ADDENDUM TO THE FINAL LONG-TERM MONITORING WORK PLAN

COLONIE FUSRAP SITE COLONIE, NEW YORK

**Contract Number W9128F-12-D-0003
Task Order Number 0022**

October 2014

FIGURE 1
SITE PLAN WITH
MONITORING WELL LOCATIONS
COLONIE FUSRAP SITE
1130 CENTRAL AVENUE
ALBANY, NY 12205

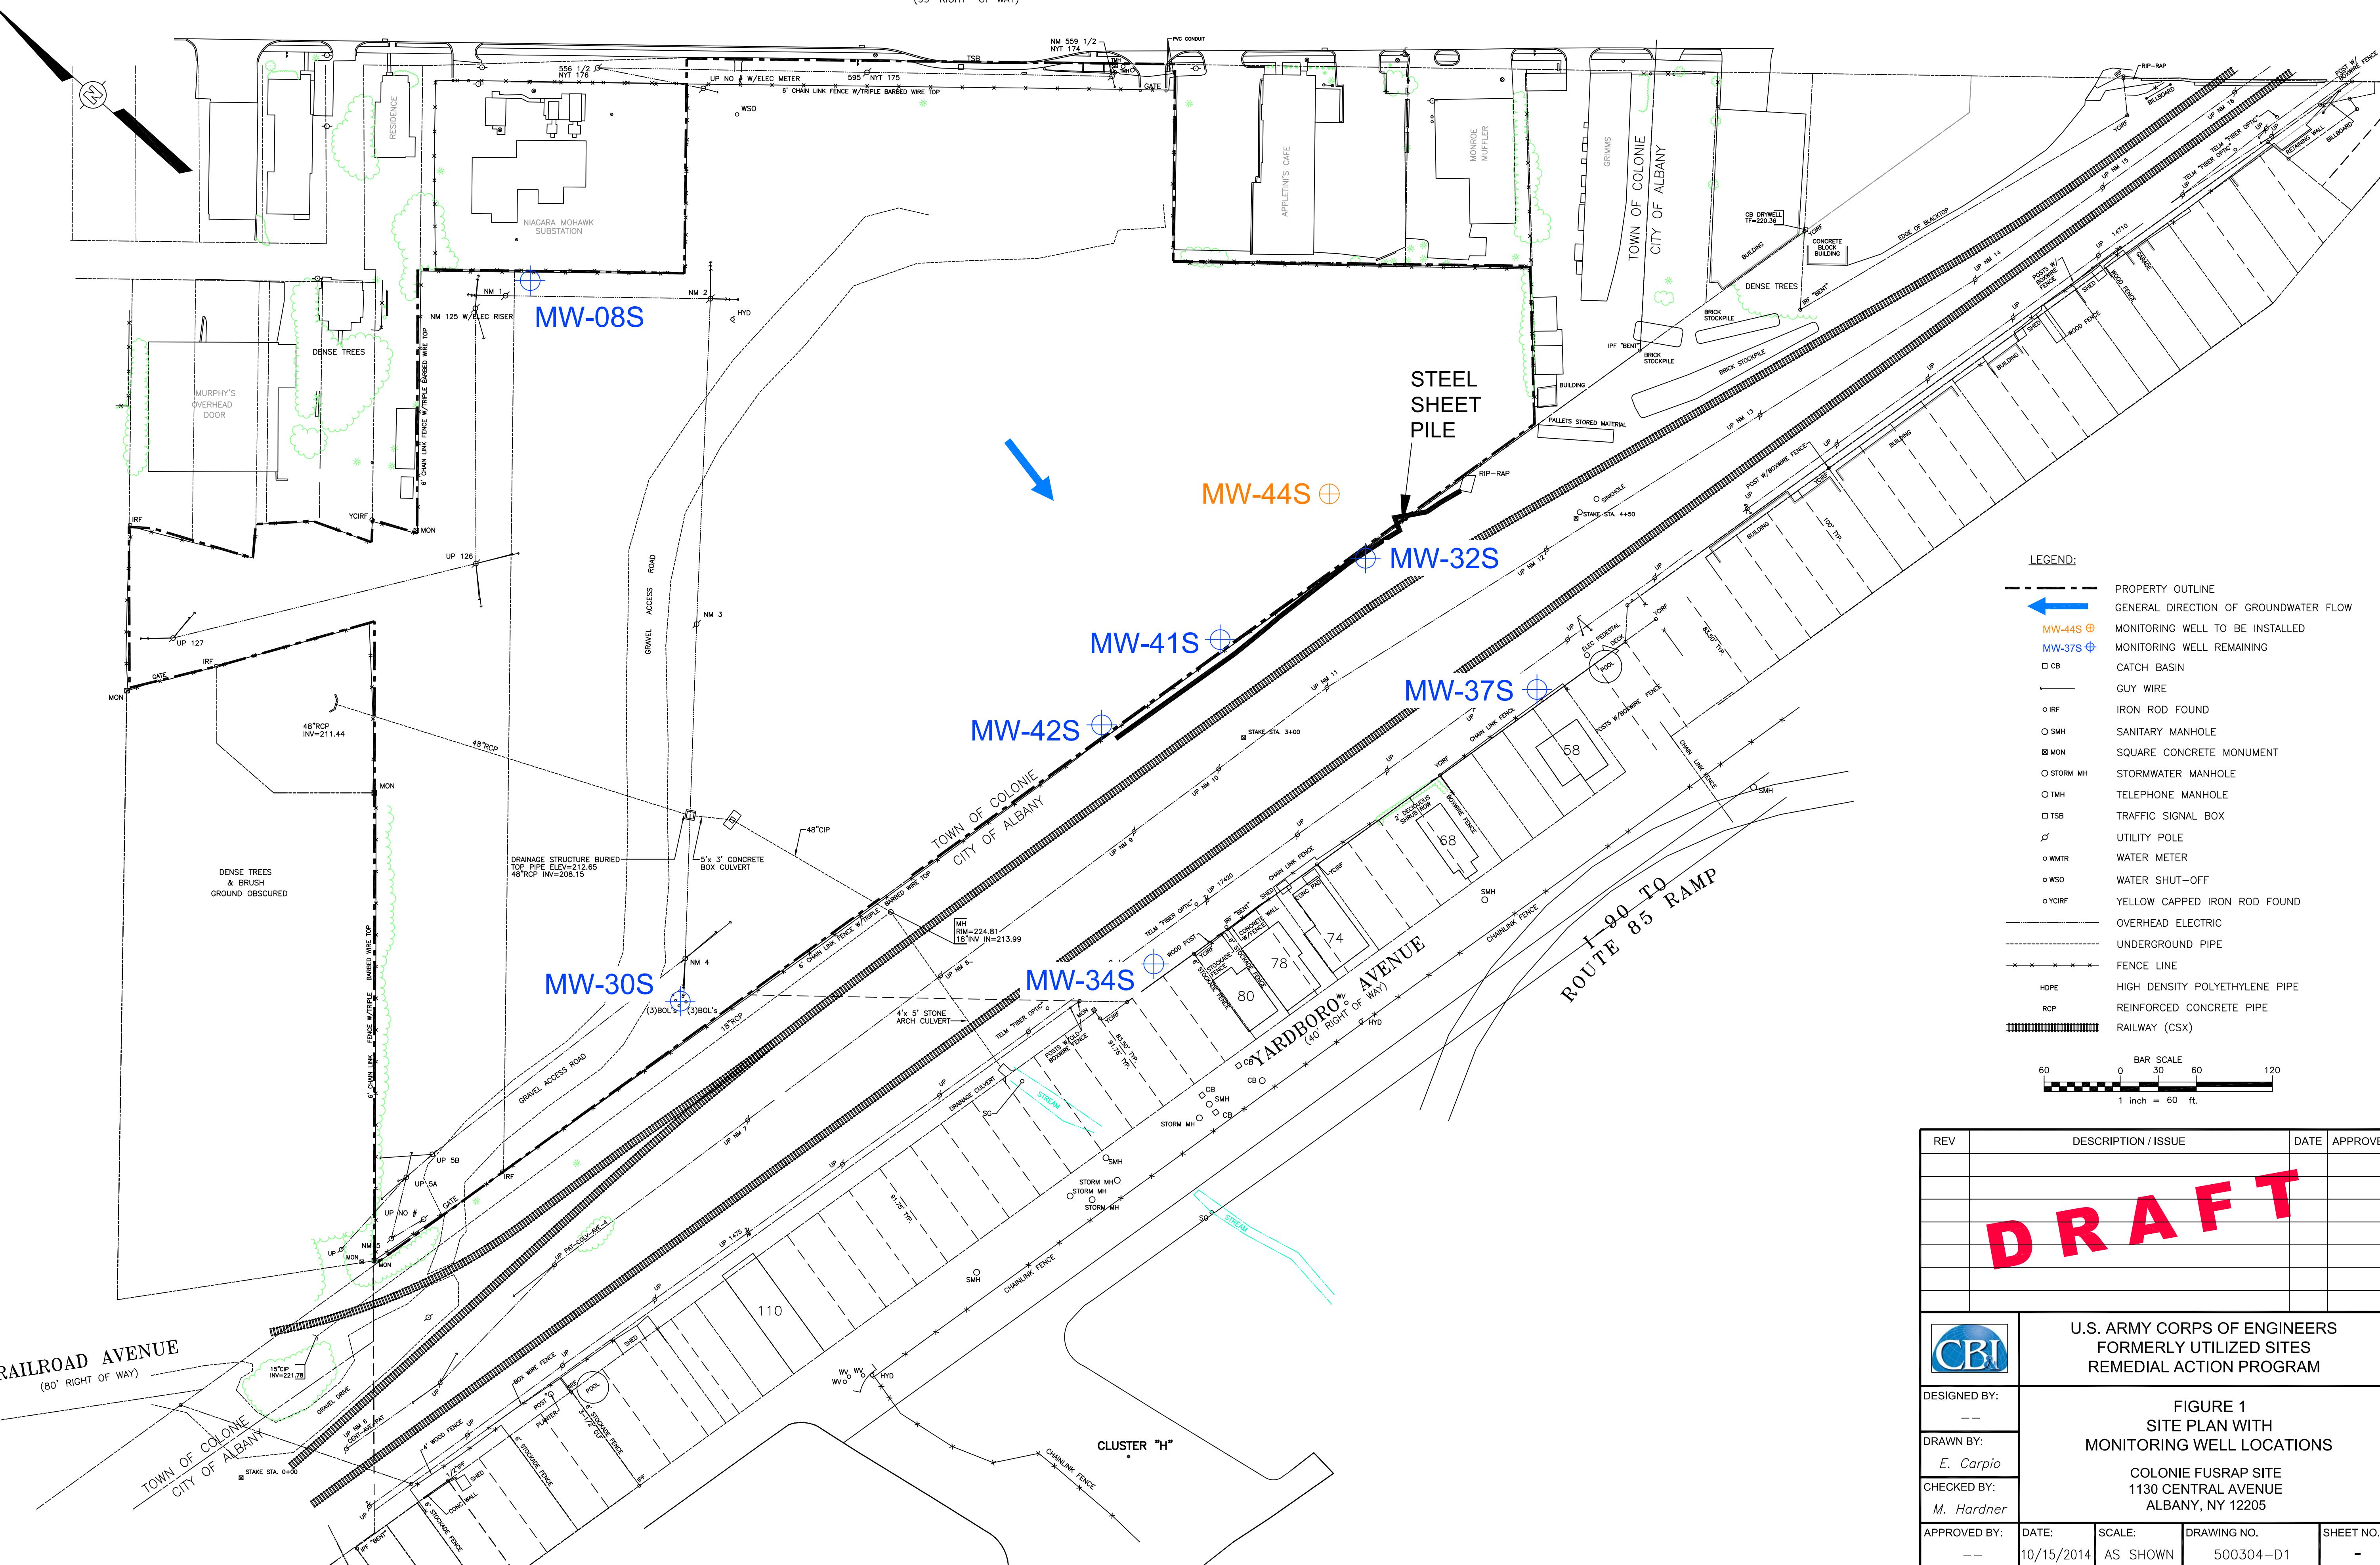
The monitoring well network for the LTM Program has been revised to include the following eight upper groundwater zone monitoring wells: MW-08S, MW-30S, MW-32S, MW-34S, MW-37S, MW-41S, MW-42S and MW-44S. Note that monitoring well MW-44S will be installed as a part of the revised program in this Addendum.

CB&I will install one new monitoring well with the designation MW-44S, to be located approximately 50 feet upgradient (north-northwest) of the sheet pile wall near monitoring well MW-32S along the southern property line. The proposed location of monitoring well MW-44S is shown on **Figure 1**.
